<b>CAMERON ENGINEERING SHOP DRAWING REVIEW FORM</b>	
<b>PROJECT NAME:</b> 2976 3rd Ave	<b>CE JOB NUMBER:</b> 21166
<b>SUBMITTAL ID:</b> 142100-1	
<b>DESCRIPTION:</b> Car Lift - VOX Elevator	
<b>OTHER:</b>

**CLIENT:** MJM ASSOCIATES CONSTRUCTION, LLC  
**SYSTEM:** VOX ELEVATOR  
**ADDRESS:** 2079 3RD AVE, THE BRONX, NY 10451

<b>SCALE:</b> N/A	<b>DATE:</b> 08/23/2022	<b>DRAWN:</b> SR	<b>CHECKED:</b> MW
<b>DRAWING NO.:</b> BX-VE-01		<b>SHEET:</b> 02 OF 05

TITLE: HYDRAULIC UNIT

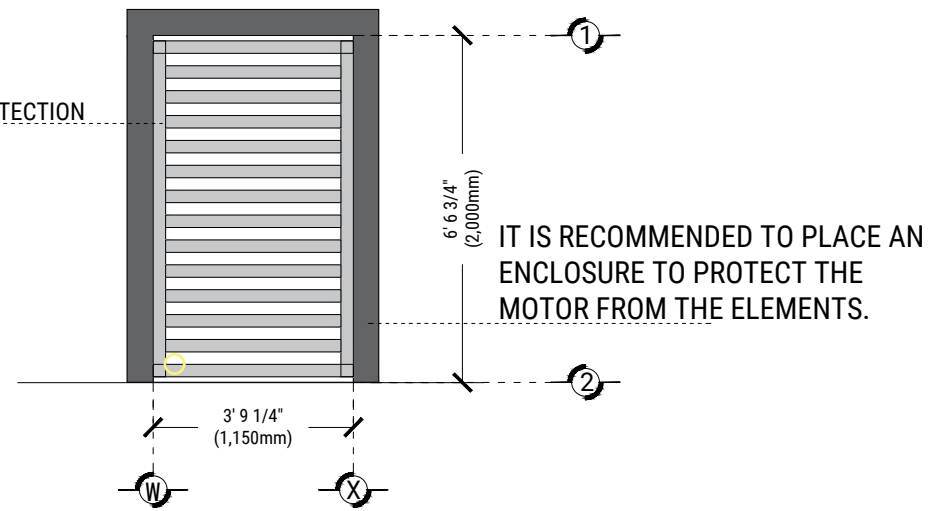
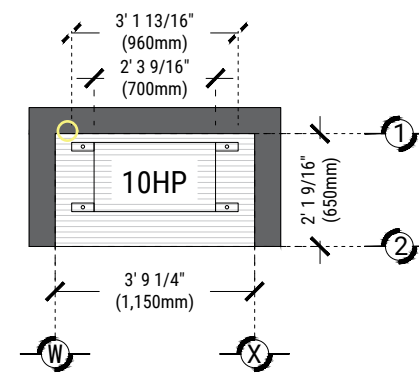
1. Please provide the heat dissipation load from the hydraulic unit, elevator control panel and provide working environment requirement so the mechanical engineer could provide proper cooling and ventilation for these units.
2. Electrical contractor shall coordinate with manufacturer for recommended power requirements and locations.
